Re: PA23-005 – Creekside PRD – Technical Review 1
7808 40th Street, 7811 & 7715 40th Street NE, APNs 29050200100200,
29050200100300, and 29050200100400

After preliminary review of the above referenced proposal, the Planning Division has the following comment(s):

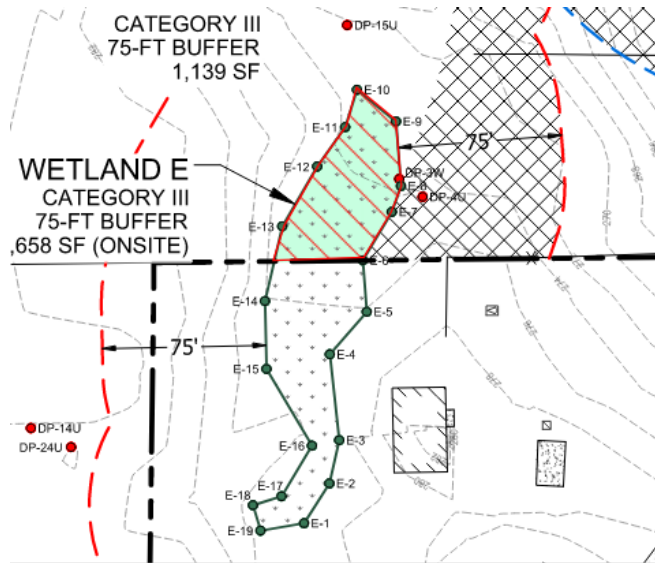
29. The Critical Areas Report identifies portions of Wetland E that are on the project site (hatched in red below), yet it is not depicted on the site plan. Buffers associated with Wetland E are not depicted on the site plan. It appears that if Wetland E and its associated buffers are depicted in their entirety that the buffer would extend into Road B and lots 24-27. It does not appear that these impacts have been addressed. Ending the wetland at the property line with no buffers is not consistent with MMC 22E.
